AN ORDINANCE AMENDING THE CARRBORO ZONING MAP TO REZONE
APPROXIMATELY .65.85 ACRES OF LAND KNOWN AS THE T.E. HOGAN HEIRS
PROPERTY FROM R-20 (RESIDENTIAL, MINIMUM 20,000 SQUARE FEET PER
DWELLING UNIT) TO VMU CU (VILLAGE MIXED-USE CONDITIONAL USE)

CONDITIONAL USE PERMIT— WINMORE VMU

VILLAGE MIXED USE REZONING AND CONDITIONAL USE PERMIT: WINMORE ARCHITECTURALLY INTEGRATED SUBDIVISION

HIGH SCHOOL ROAD INTERSECTION

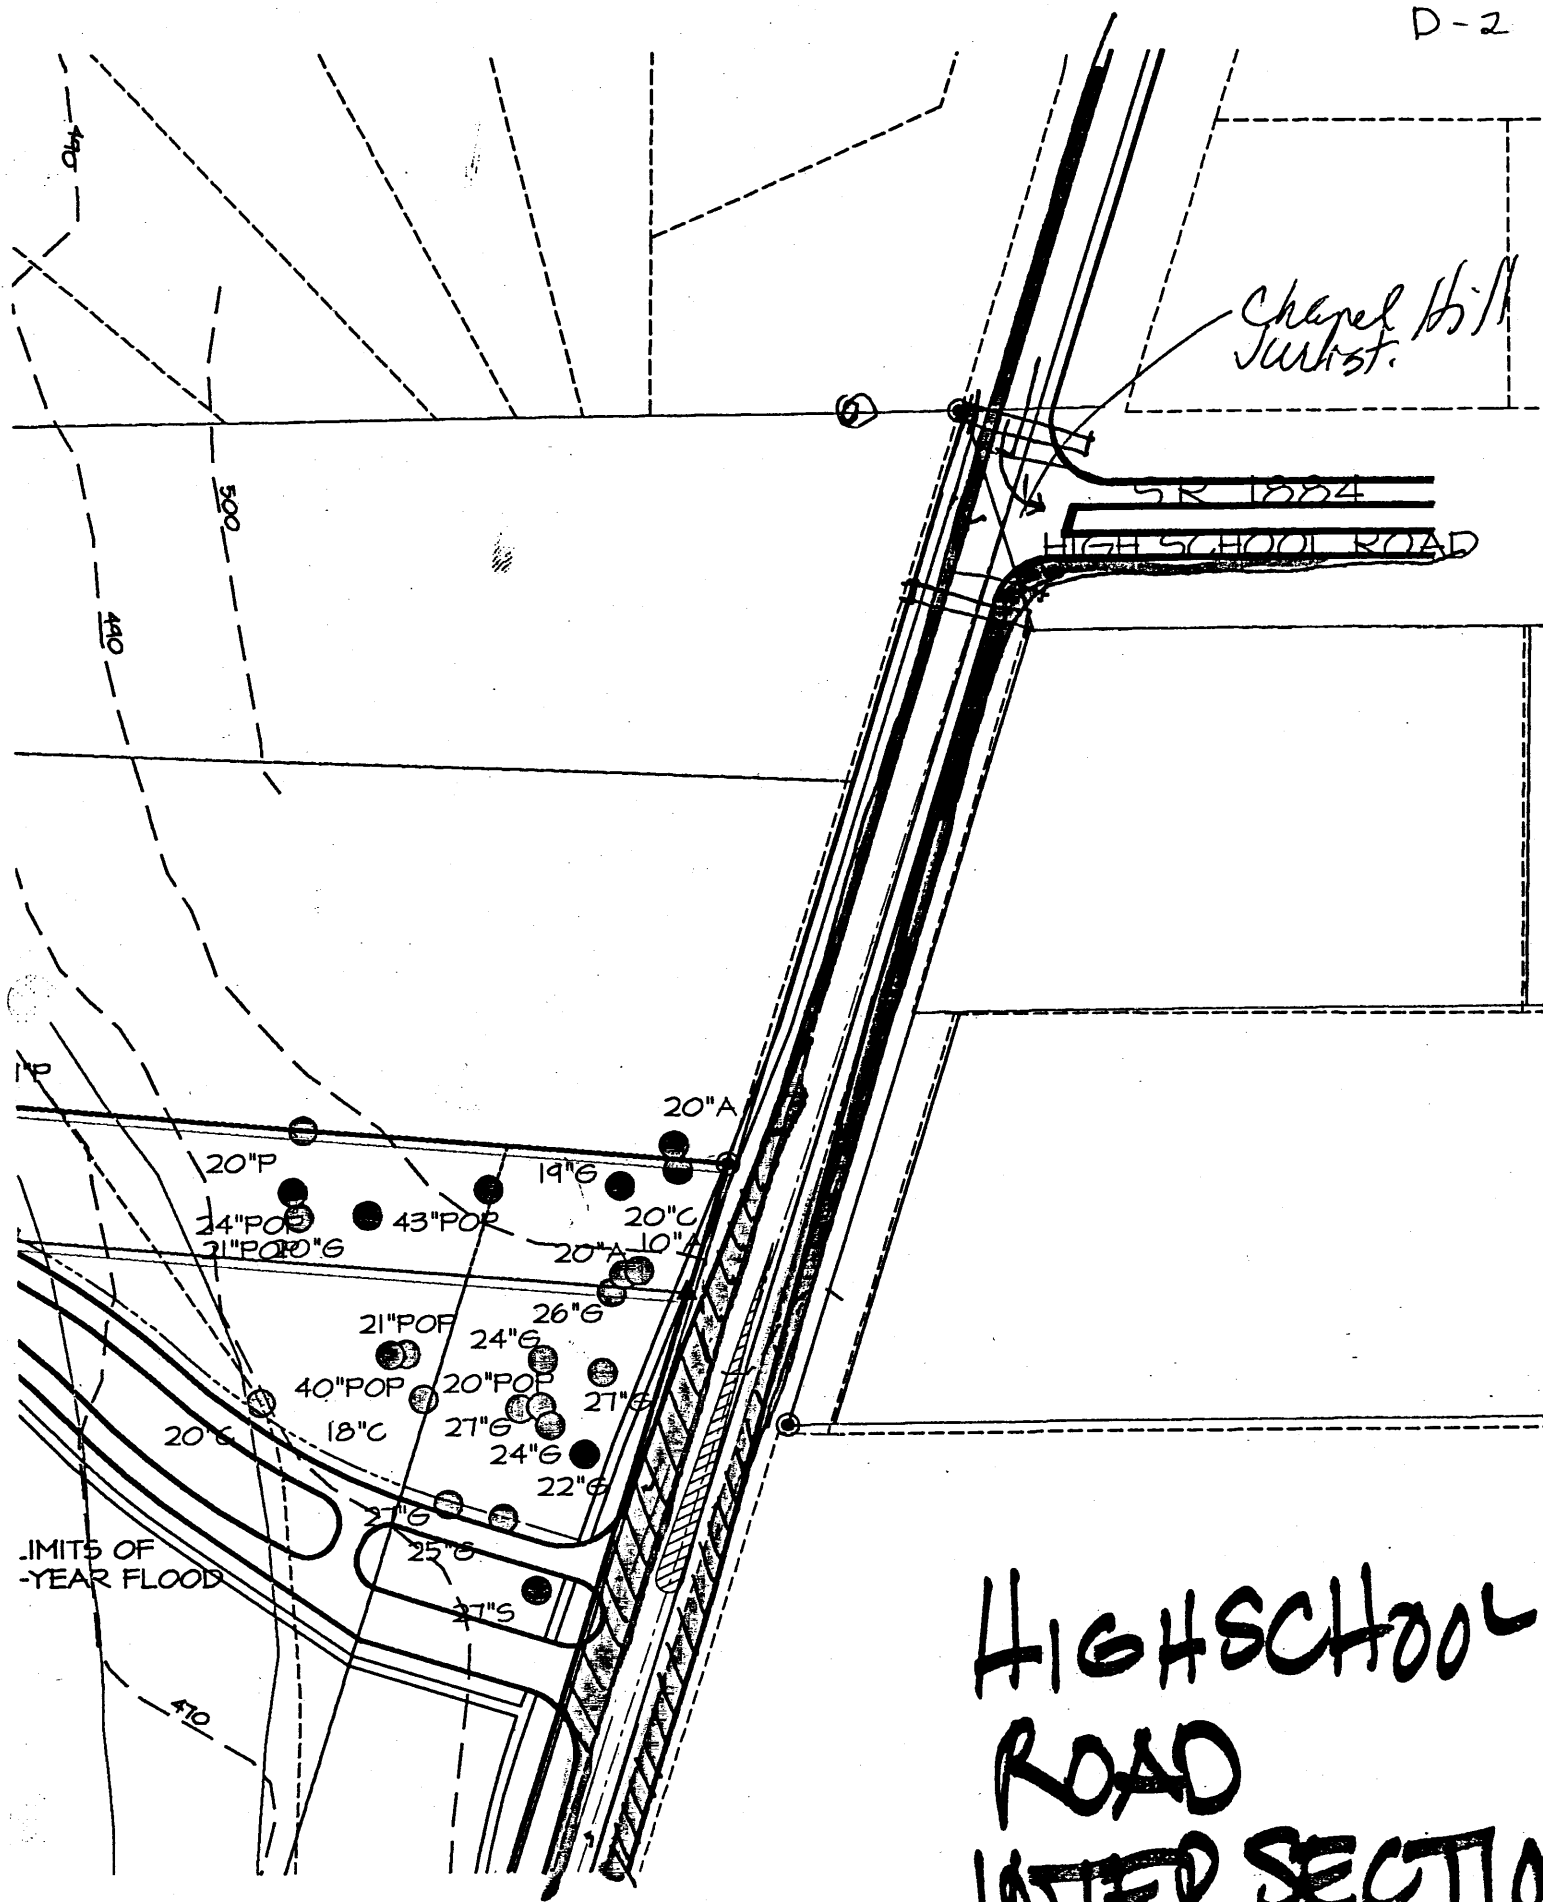
2. The developer should share in the cost of a roundabout or other traffic-calming facility at the intersection of High School and Homestead roads.
3. That no C.O.'s be issued until the sidewalk and intersection improvements have been made on Homestead Road.

6. Motion to require the developer to extend the proposed sidewalk along Homestead Road to connect with the sidewalk at Camden Lane. (3 Ayes, 1 Noe).
7. Motion to recommend that the Town of Carrboro work with Orange County and the Chapel Hill Carrboro School System to fund a crossing guard for the intersection of High School Road with Homestead Road. (4 Ayes)
